**FILE NUMBER:** 18-DP-20

**SUBJECT:** Site Plan Review for a mixed-use development consisting of hotel and residential uses (Ocean Park View Hotel).

PROPOSED HOTEL DEVELOPMENT FOR:  
OCEAN PARK VIEW HOTEL  
1005 E. DANIA BEACH BLVD.  
HOLLYWOOD, FLORIDA.

SP-1.1

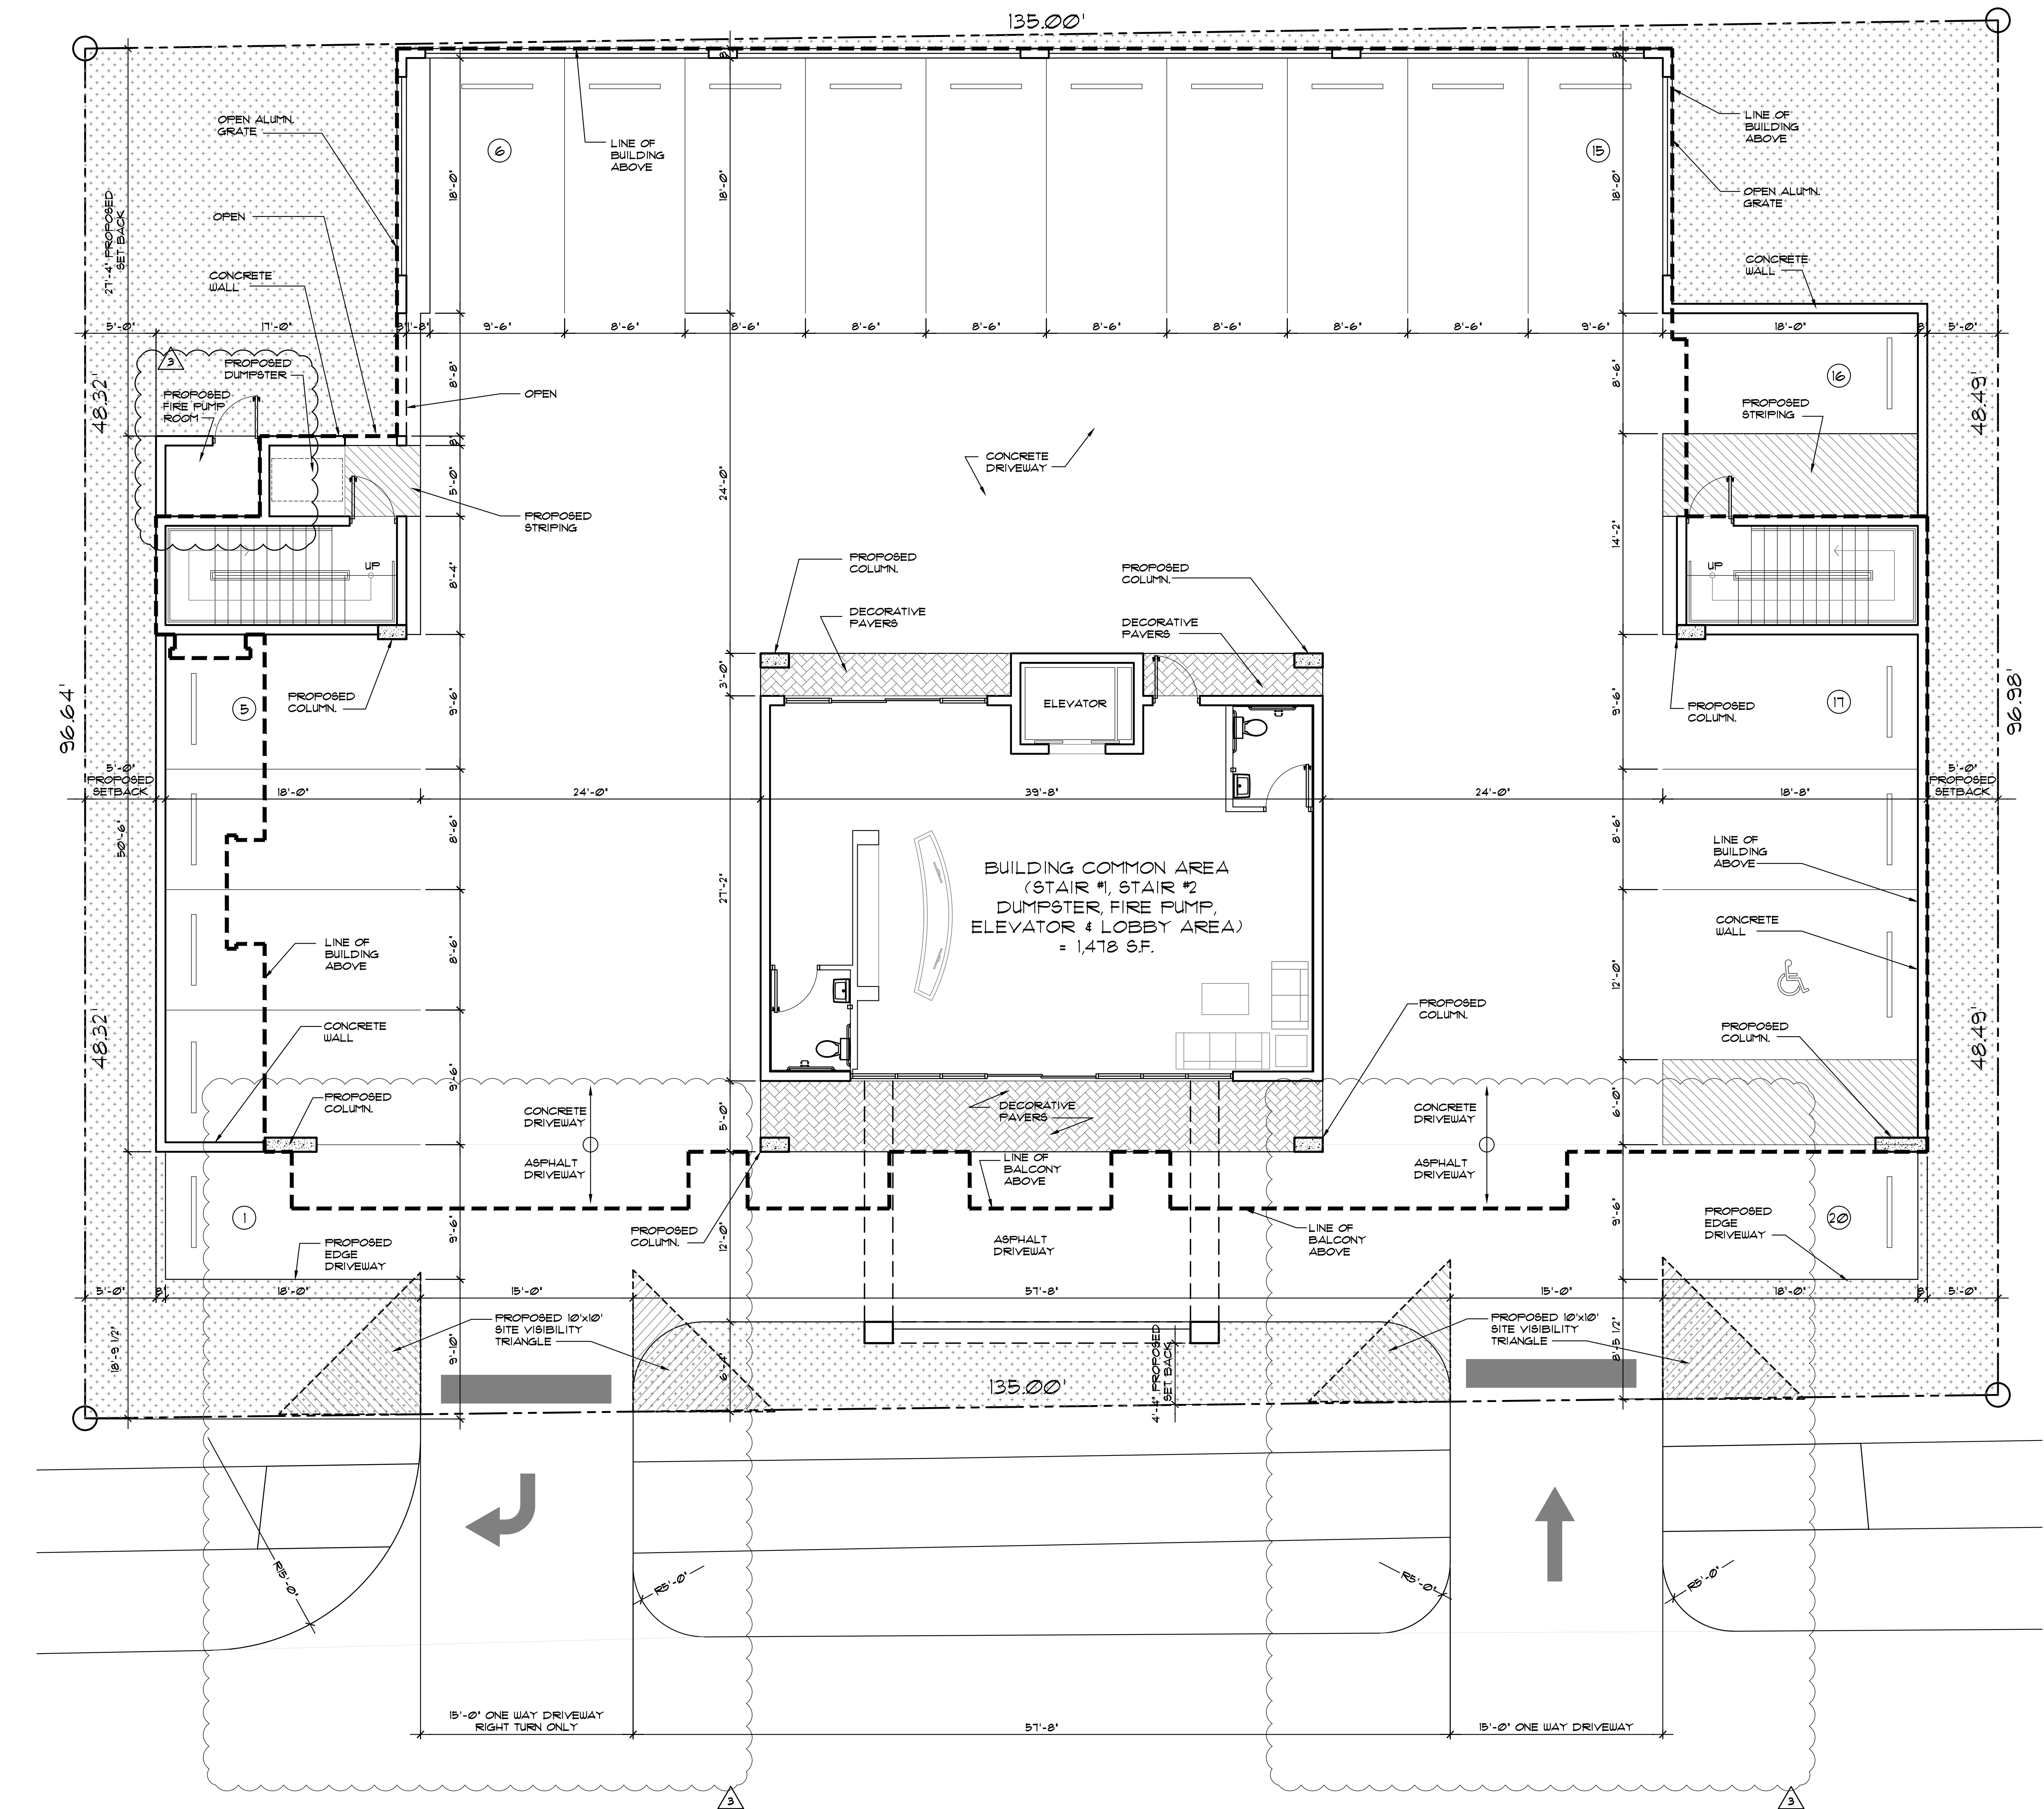
2. Parking at rear shall have a 5' landscape setback. Revise accordingly.

1. Sheet SP-1.1: How is recycling being done in the building? Is there a special trash chute that can switch between recycling and regular trash? Only one dumpster is shown and it does not have gates.

2. Sheet SP-1.1: The west staircase exits in garage area not open air.

3. Sheet SP-1.1: There should be a pedestrian connection to the existing sidewalk at the street.

1. Provide pedestrian connectivity to the public rights-of-way, Dania Beach Boulevard.

4. Minimum driveway separation for non-residential properties is 50 feet, Code 155.08(E).

***Response: Refer to sheet SP-1.1. Provided wall to rear setback of zero with amenities deck above. No Landscape buffer required***

***Response: Refer to A-1.2 showing trash and recycling chute. Garbage and recycling containers will be wheeled out to front of property for pick up.***

***Response: Refer to sheet A-1.1 showing both stairs exiting to open air***

***Response: Refer to SP-1.1.***

***Response: Refer to SP-1.1***

***Response: Revised site plan as per DOT requirements. We have provided a 15' one-way and 15' one way out (right turn only) as per DOT's request. Driveway expands to 24' as required by City of Hollywood. Refer to sheet SP-1.1 and A-1.1. We have attached DOT letter stating their requires and no objections to having two driveways.***

A-1.3

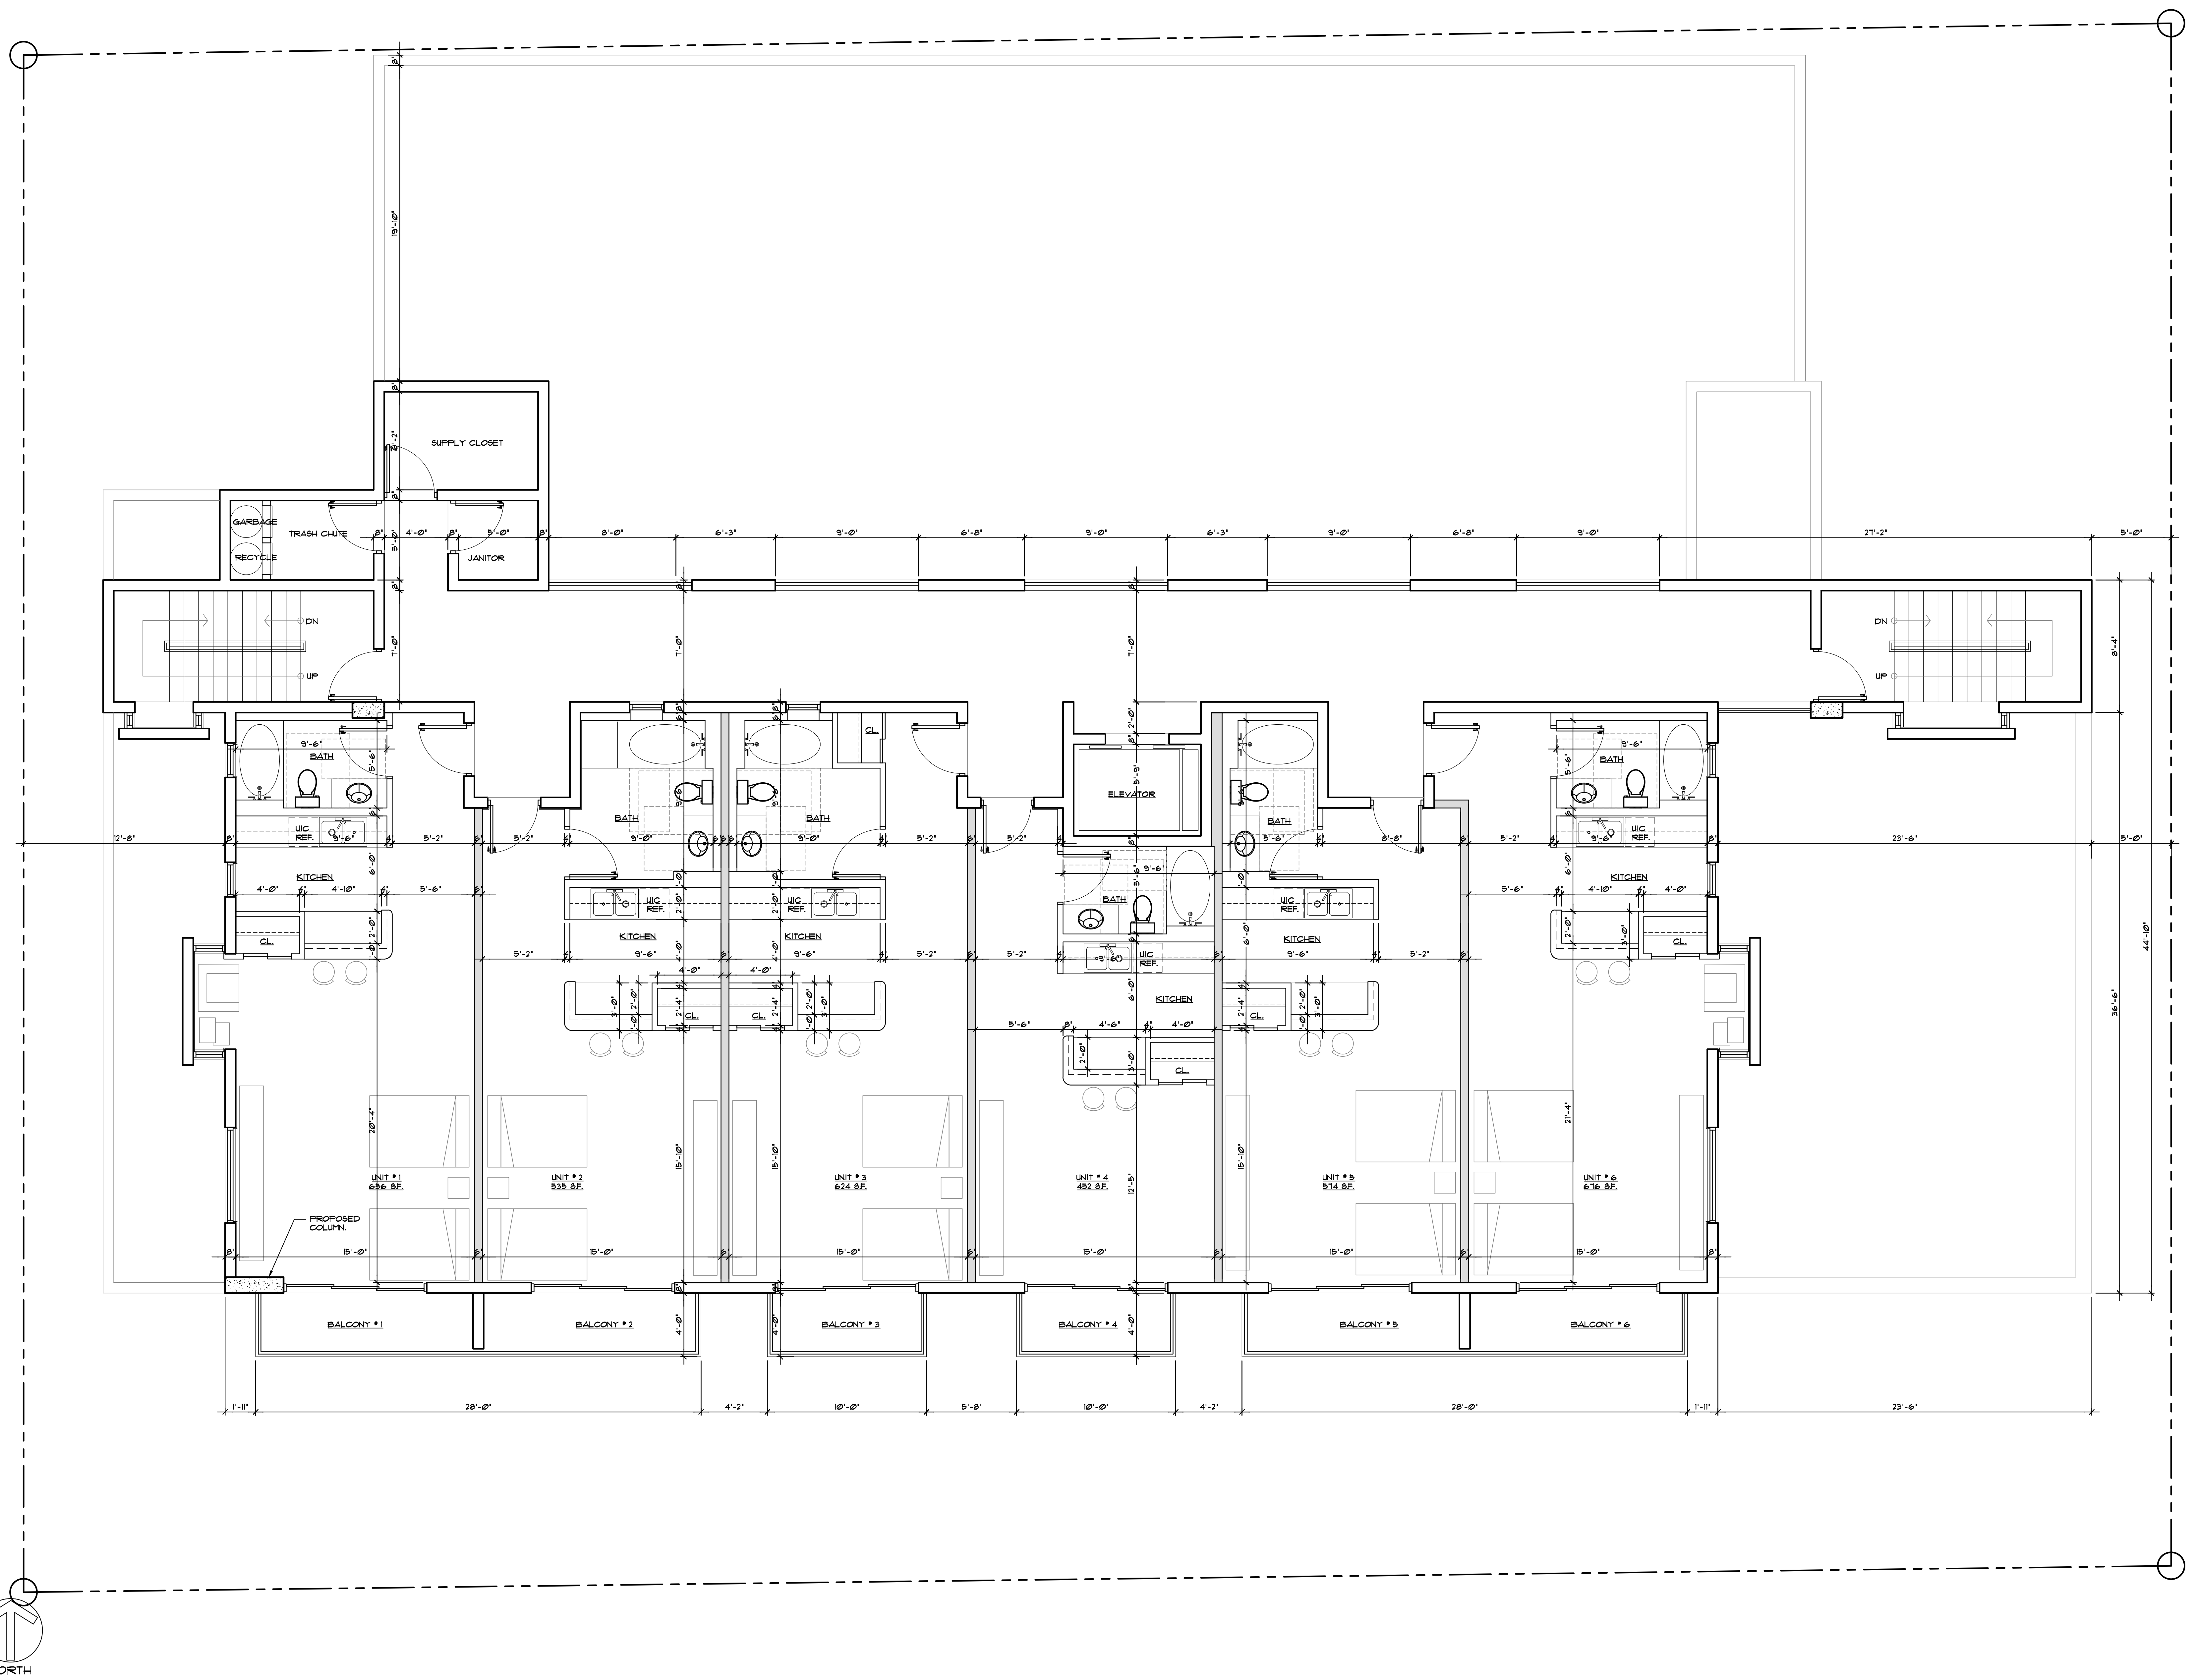
5. Sheet A-1.3: The exit corridor from the Great Room to the door is only 3'-0" wide.  
**Response: Refer to sheet A-1.3 revised to 44"**
6. Sheet A-1.4: Where is the roof top HVAC equipment? Is it fully screened? For ADA purposes the elevator should access the Terrace level.  
**Response: Refer to sheet A-1.4 roof plan showing Condensing unit mounted and screened. Elevator has access to 2<sup>nd</sup>. Floor amenities deck.**
7. Sheet A-2.1: Stucco control joints are not shown and materials are not identified on the elevations.  
**Response: Refer to Elevation sheets**
